গণপ্রজাতন্ত্রী বাংলাদেশ সরকার শ্রম ও কর্মসংস্থান মন্ত্রণালয় কলকারখানা ও প্রতিষ্ঠান পরিদর্শন অধিদপ্তর

ক্যাপ পর্ববেষ্ফণের তখ্য

কারখানার নাম	ইমাজ ক্যাশন ওয়্যার লিঃ
ঠিকানা	Holding # 119, Ward # 03, Block # D, Ashulia Main Road, Turag, Dhaka
কারখানার কোড	DHK181
কালার কোড

মুল্যামনের ধরণ: কাঠামোগত মুল্যামন	পর্ববেষ্ফণের তারিখ: ০২–০৪–২০২৩
১. পর্ববেষ্ণণ

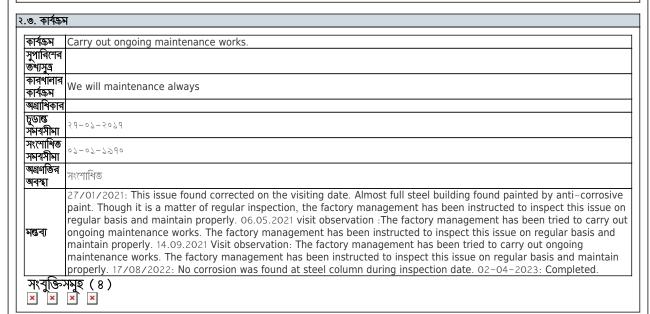
পরিদর্শন পর্ববেষ্ডণ	Over stress has been found in corner column.
ক্যাপ	
আইটেম	
ক্যাটাগরি	•

১. কাৰ্যক্ৰম	
<u>কাৰ্যক্ৰম</u>	Factory Engineer to review design, loads and columns stresses in the area identified above
সুপারিশের তখ্যসূত্র	
কার্যথানার কার্যক্রম	We wil engage a consulting firm to solve this issue
অগ্রাধিকার	৬ সপ্তাহ
চুডান্ড সমশ্বসীমা	o ⋈ − o ⋈ − ₹ o √ ⋈
সংশোধিত সমশ্বসীমা	02-02-2290
অগ্রগতির অবস্থা	চলমান
মন্ত ব্য	06/09/2020: DEA not Completed yet. After completion of DEA it will be submitted to DIFI for approval. 06.05.2021 visit observation: The factory management have submitted asbuilt architectural drawing, as-built structural drawing & floor load plan drawing to DIFE RCC on 24/09/2018 without any DEA report. Now the factory management is instructed to submit all these design & drawings & documents along with DEA and soft copy CD files to DIFE RCC as soon as possible. 14.09.2021 Visit observation: The factory management have submitted as-built architectural drawing, as-built structural drawing & floor load plan drawing to DIFE RCC on 24/09/2018 without any DEA report. Now the factory management is instructed to submit all these design & drawings & documents along with DEA and soft copy CD files to DIFE RCC as soon as possible. 17/08/2022: DEA report must be resubmitted to DIFE for approval as soon as possible. 02/04/2023: DEA work is pending due to factory have not appointed any consultants regarding it.
